**CLARIFICATION # 6**  
**FOR**  
**PROCUREMENT OF PLANT DESIGN, SUPPLY, DELIVERY, INSTALLATION, TESTING AND COMMISSIONING**  
**OF**  
**LOT 1: LAPSIPHEDI-RATMATE-NEW HETAUDA 400kV D/C TRANSMISSION LINE**  
**LOT 2: RATMATE-NEW DAMAULI 400kV D/C TRANSMISSION LINE**  
**LOT 3: NEW DAMAULI-NEW BUTWAL 400kV D/C TRANSMISSION LINE (BASE) AND NEW BUTWAL -**  
**NEPAL/INDIA BORDER 400kV D/C TRANSMISSION LINE (OPTION)**

**Ref No: MCA-N/ETP/CB/003**

**Issued on: 24 March 2023**

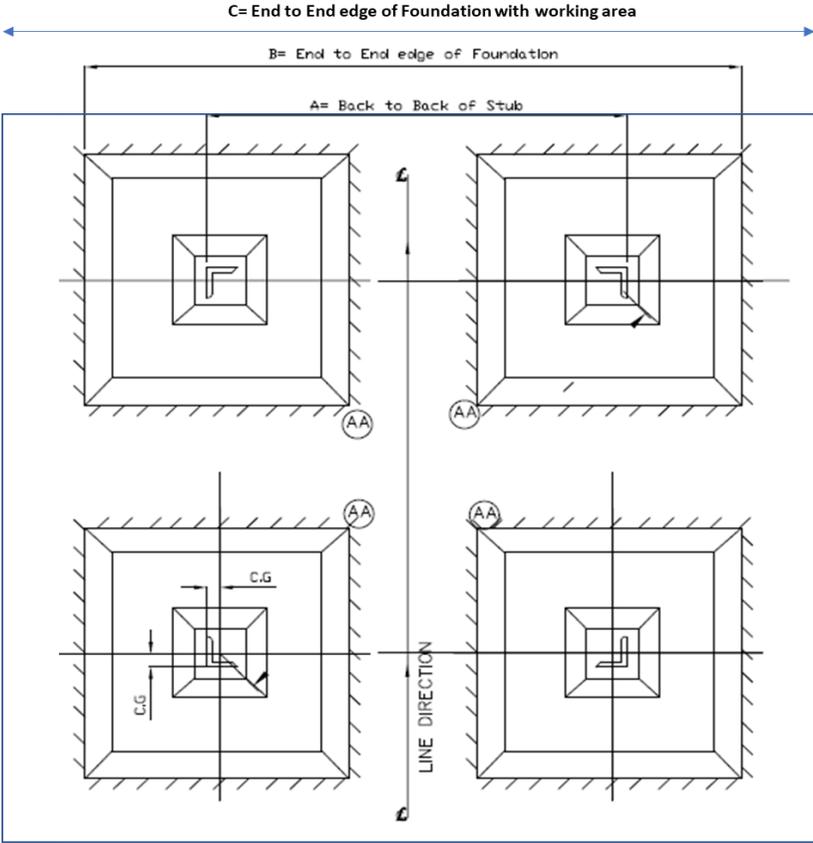
SN	Questions from Bidders	Response of Millennium Challenge Account Nepal (MCA-Nepal)
	<p>Both the clarification are contradicting, as it does not clarify whether the working area is part of foot print. Please confirm as per below diagram the font print provided in addendum is B or C.</p>  <p>The diagram illustrates four cross-sectional views of a foundation structure. The top two views show the foundation with a central stub. Dimension lines indicate:     <ul style="list-style-type: none"> <li><b>C</b>: End to End edge of Foundation with working area (the outermost boundary).</li> <li><b>B</b>: End to End edge of Foundation (the boundary of the foundation itself).</li> <li><b>A</b>: Back to Back of Stub (the width of the central stub).</li> </ul>     Section lines AA-AA are shown across the views. The bottom two views show the foundation with a central stub and a central core. Dimension lines indicate:     <ul style="list-style-type: none"> <li><b>C.G.</b>: Center of Gravity (indicated by arrows pointing to the center of the stub and the core).</li> <li><b>LINE DIRECTION</b>: Indicated by a vertical arrow pointing downwards.</li> </ul> </p>
